UNITED STATES PATENT AND TRADEMARK OFFICE

| APPLICATION NO. | FILING DATE | FIRST NAMED INVENTOR | ATTORNEY DOCKET NO. | CONFIRMATION NO. |
|-----------------|-------------|----------------------|---------------------|------------------|
| 09/720,235 | 12/20/2000 | Akito Nishimura | 14998-255 | 1247 |

Office Action Summary

DETAILED ACTION

FIG. 2

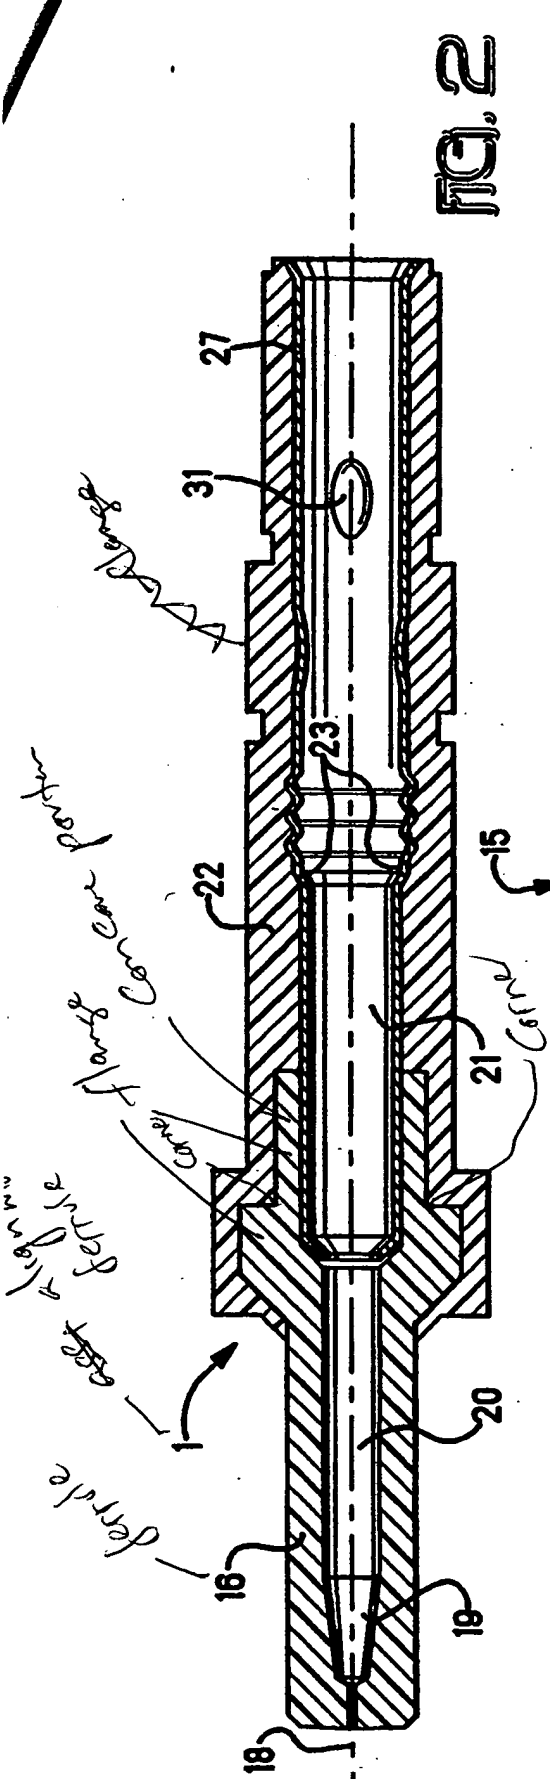
Edwards et al discloses an optical ferrule (1, 16), a concave portion (see marked figure 2, attached), an optical fiber insertion opening portion, an optical fiber insertion hole opened in a connector connecting end, a guide pin hole (20) for inserting a guide pin (19), the guide pin positioning the ferrule body, a flange portion (see marked figure 2, attached) protruding from an external periphery surface of the ferrule body provided in a rear end portion opposed to the connector connecting end face, the concave portion is formed in an external surface of the flange portion, the concave portion is formed in each of right and left side surfaces of the external periphery surface of the flange portion, the concave portion is formed so as to extend from the side surface to a rear end corner portion, the concave portion is formed between both corner portions of the side surface (see marked figure 2, attached), the concave portion is formed in a groove shape extending over the whole length of the flange portion in a connector connecting direction,

FIG. 4

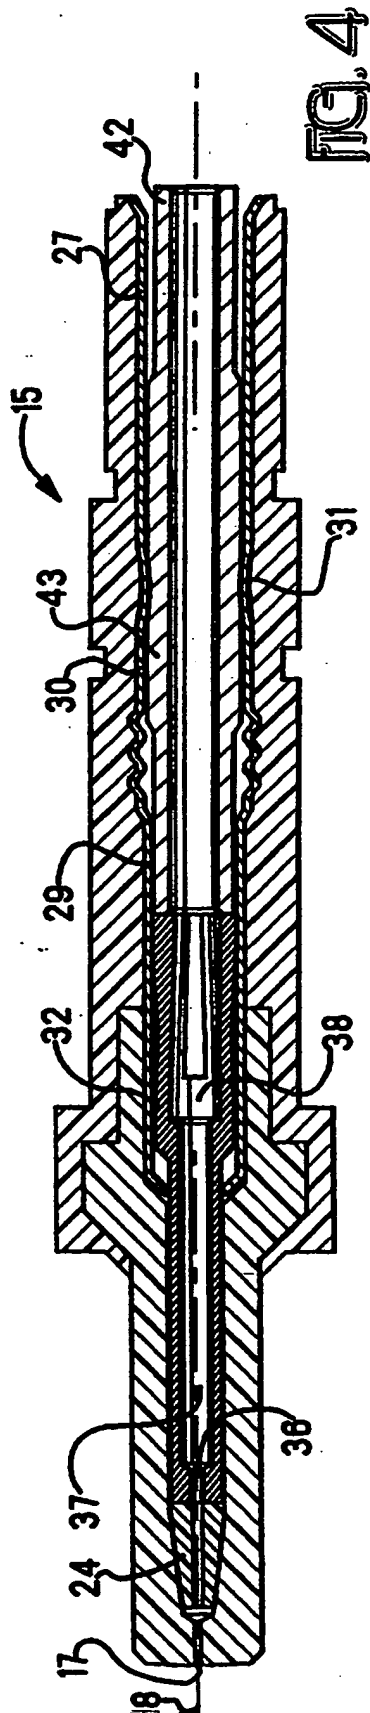
Bunin et al discloses an optical ferrule (50), a concave portion (see marked figure 4, attached), in which a gate (22) in resin molding is disposed is formed in a body, an optical fiber insertion opening portion, an optical fiber insertion hole opened in a connector connecting end (56), a guide pin hole for inserting a guide pin (60, 88, see col. 6, lines 5-8), the guide pin positioning the ferrule body, the concave portion is formed at a portion other than the flange portion (see marked figure 4, attached),
